**R.I.D.E.M. PRELIMINARY DETERMINATION AND
R.I.D.O.T. PHYSICAL ALTERATION PERMIT
SITE PLANS
FOR
TOWN OF BURRILLVILLE
GONYEA MEMORIAL PARK
A.P. 191, LOTS 114 AND 135
A.P. 192, LOT 17
HIGH STREET
BURRILLVILLE, RHODE ISLAND**

DEPARTMENT OF ENVIRONMENTAL MANAGEMENT
OFFICE OF WATER RESOURCES
FRESHWATER WETLANDS PROGRAM
APPROVED WITH CONDITIONS
AS SPECIFIED IN THE LETTER OF APPROVAL
DATED AUG 21 2014 FILE # 14-0127
NO CHANGES ALLOWED WITHOUT PRIOR APPROVAL
APPROVED PLANS MUST BE AT CONSTRUCTION SITE

AGENCY REVIEW SUBMISSION

GONYEA MEMORIAL PARK PROJECT

DRAWING TITLE:
GRADING AND DRAINAGE PLAN NO.1

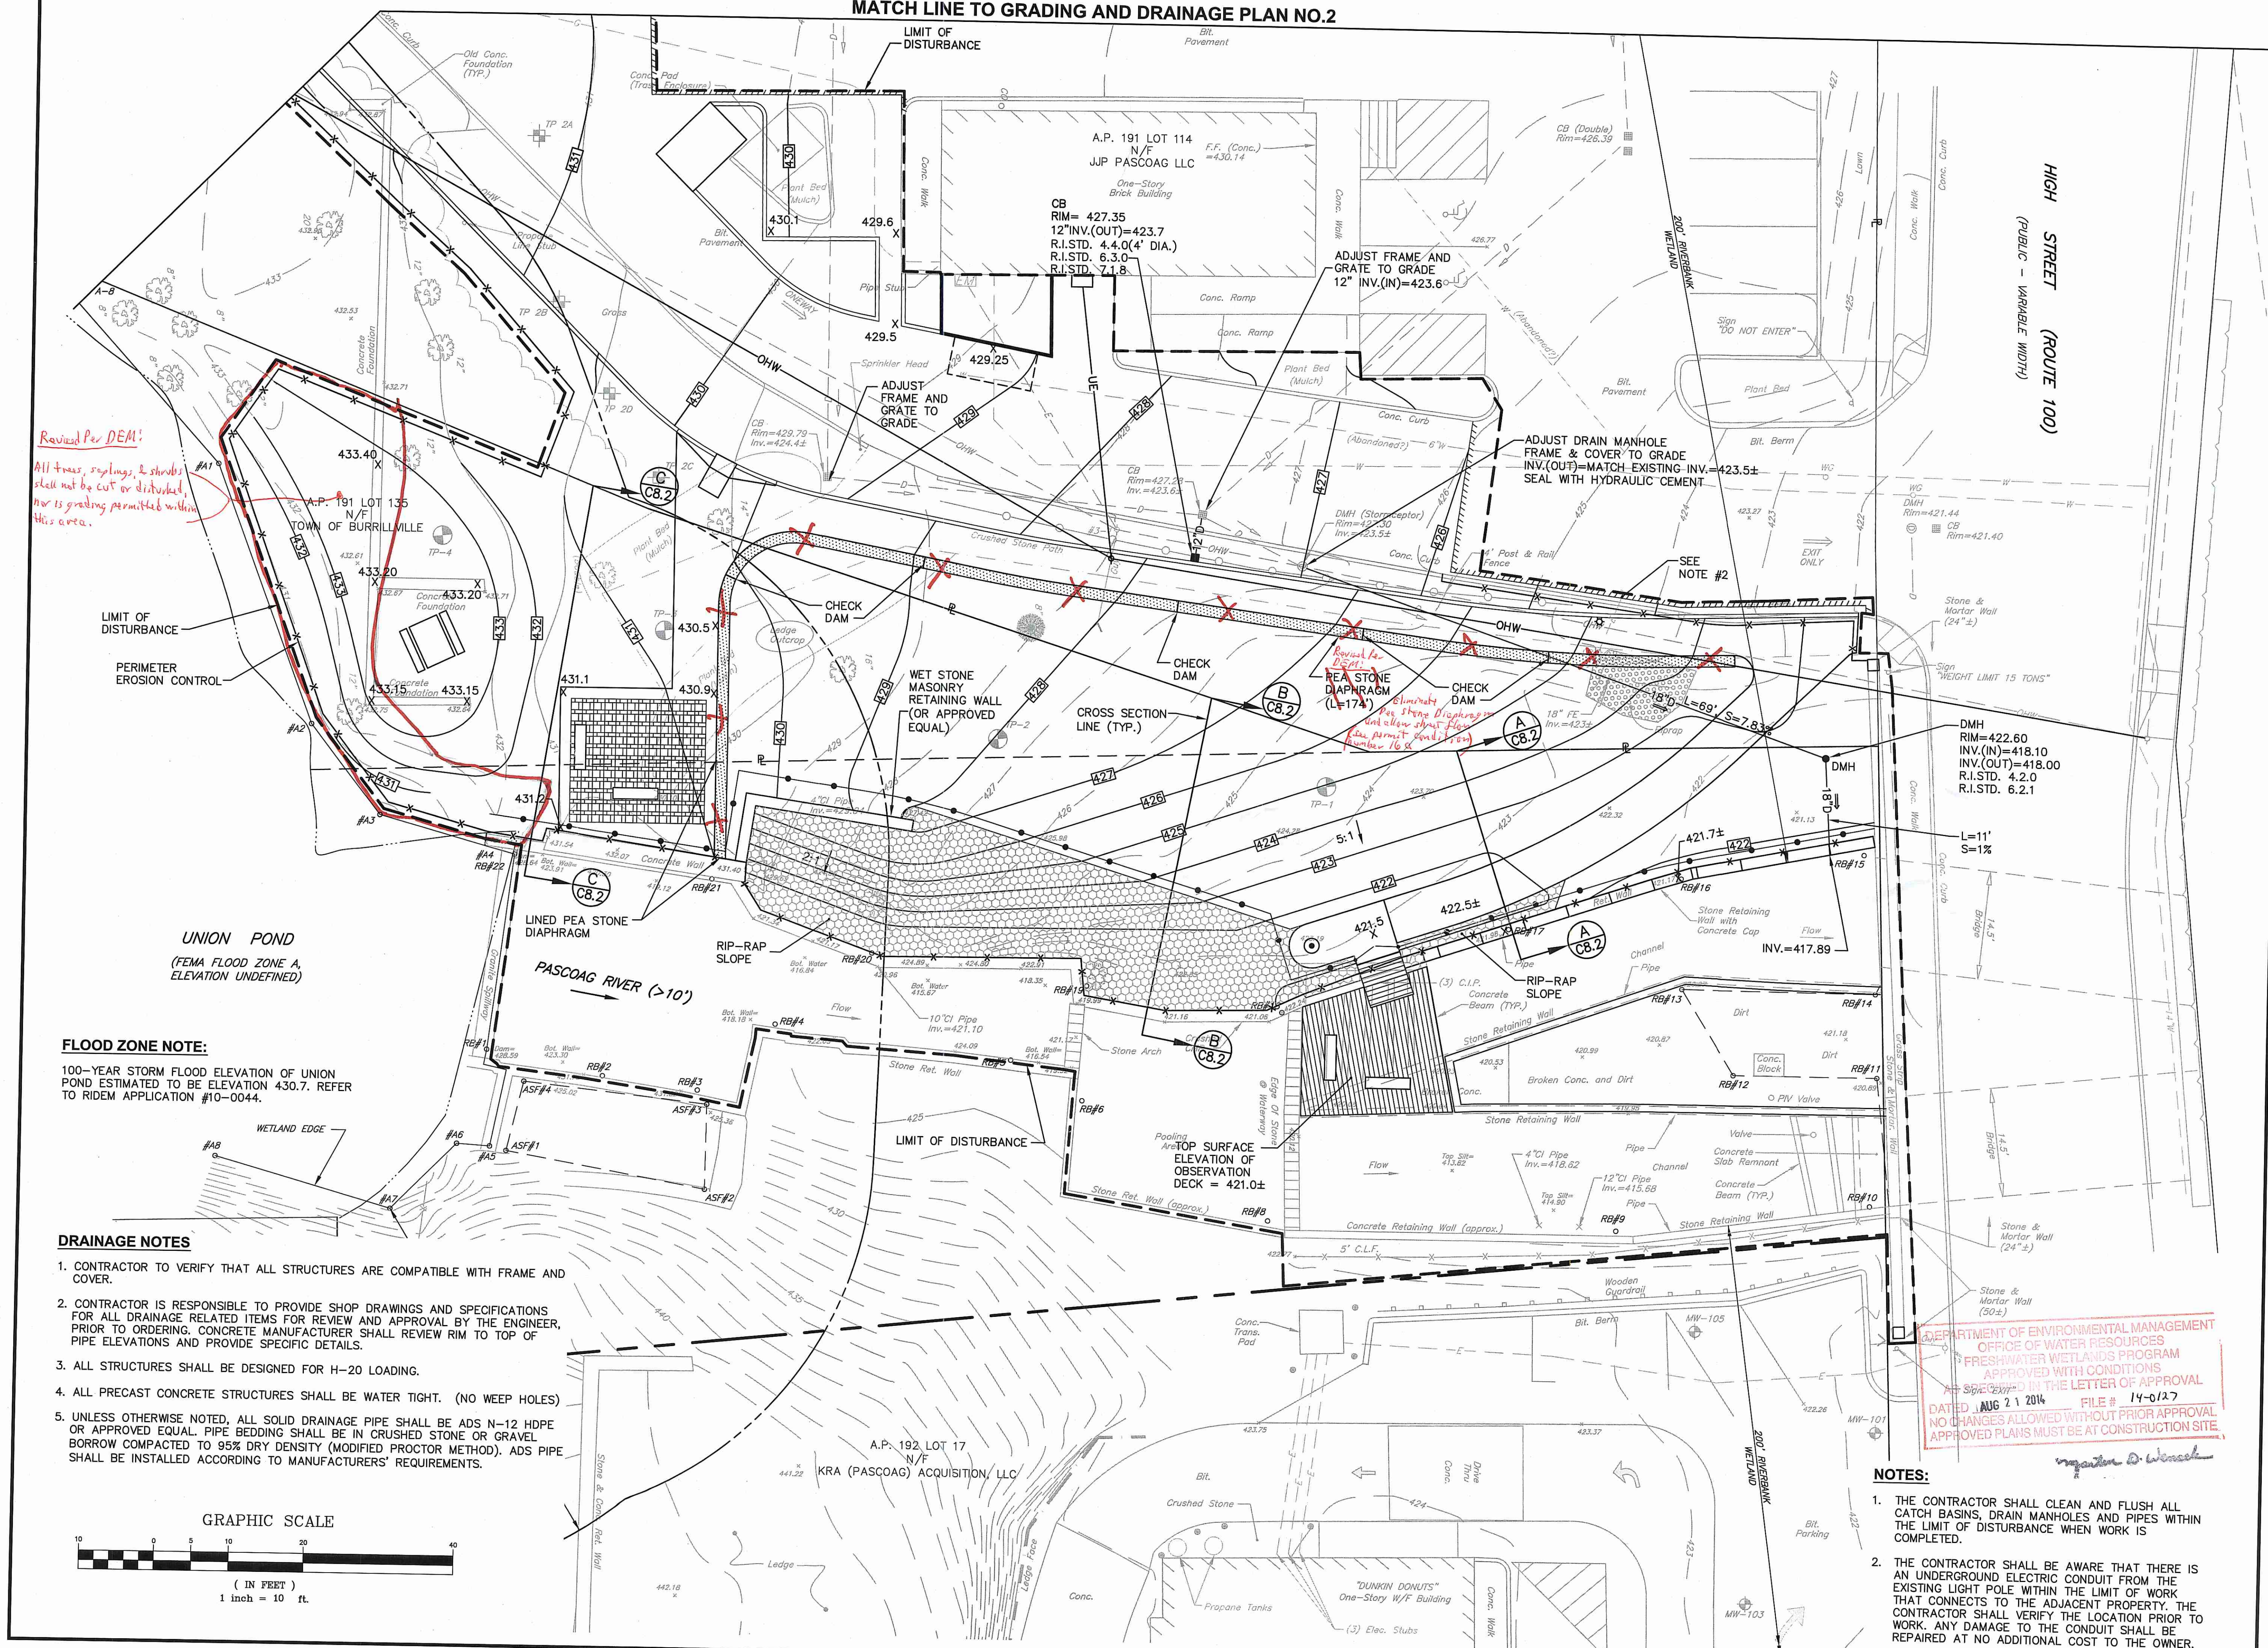
Revised Per DEM!
 All trees, saplings, & shrubs shall not be cut or disturbed, nor is grading permitted within this area.

DRAWING TITLE:
**LANDSCAPE PLAN
NO.1**

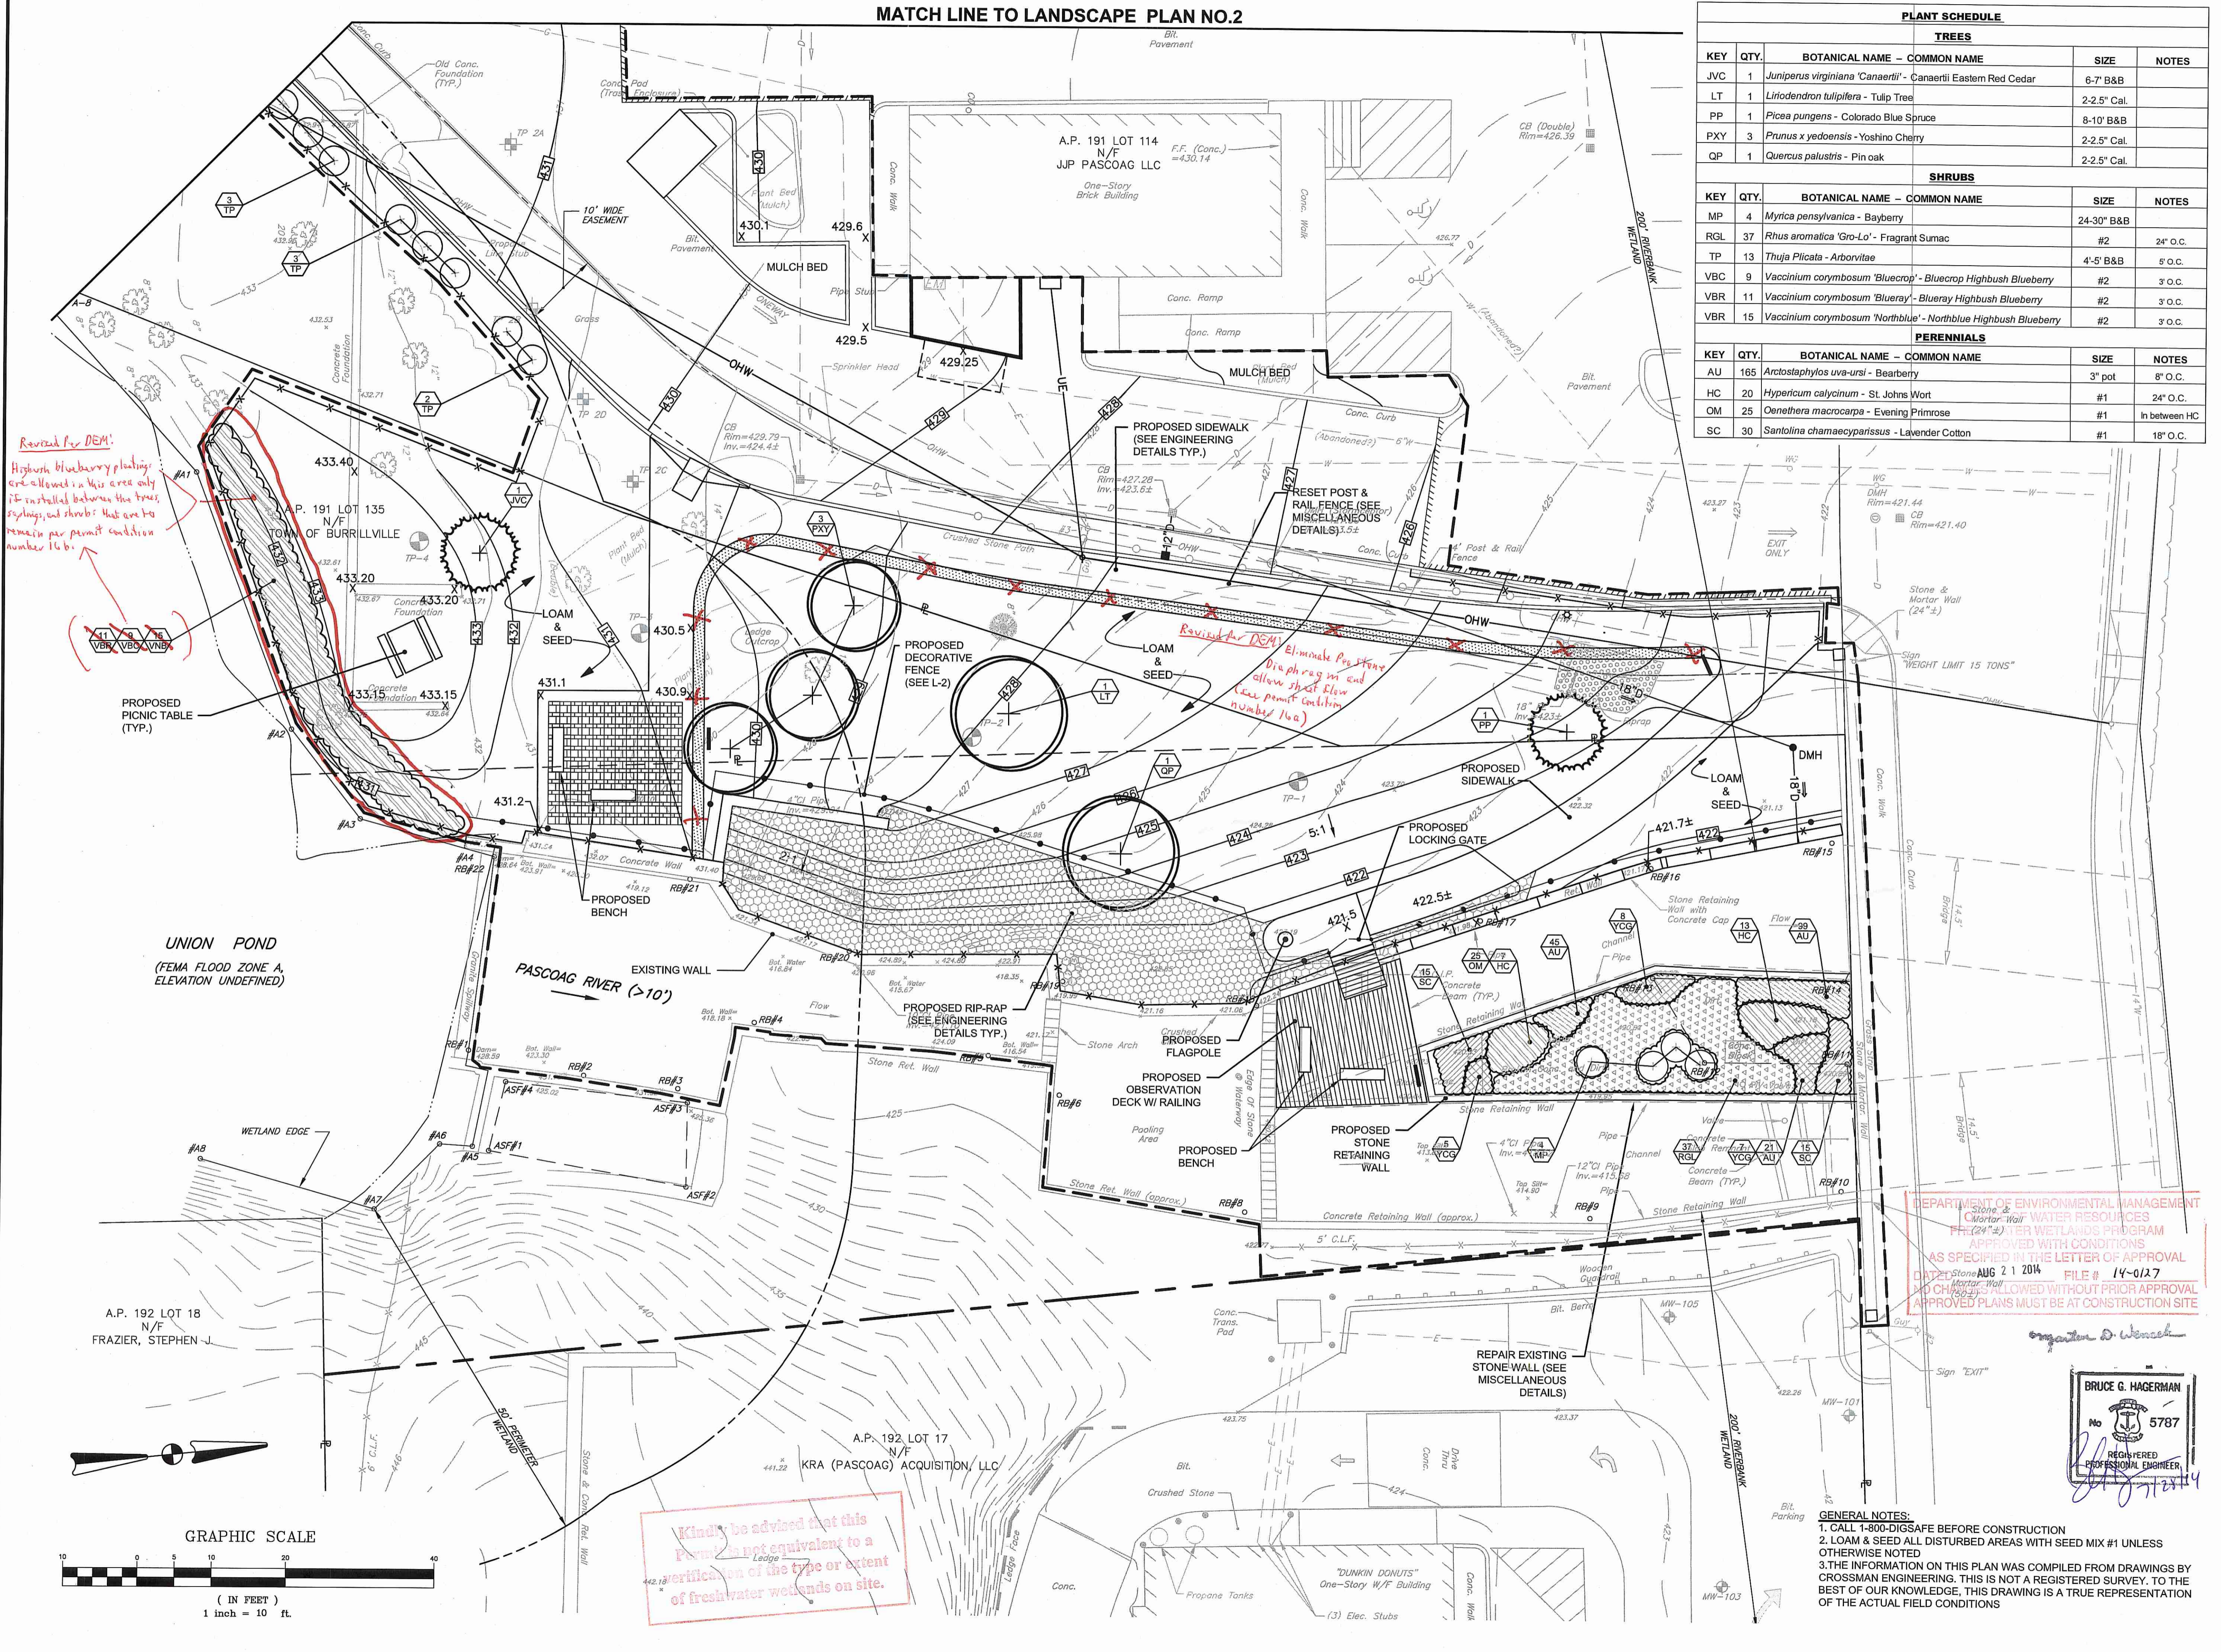
Revised for DEM:
Highbush blueberry plantings are allowed in this area only if installed between the trees, shrubs, and shrubs that are to remain per permit condition number 16 b.

Revised for DEM:
Eliminate Per Stone Dip on ramp in end use permit condition number 16a
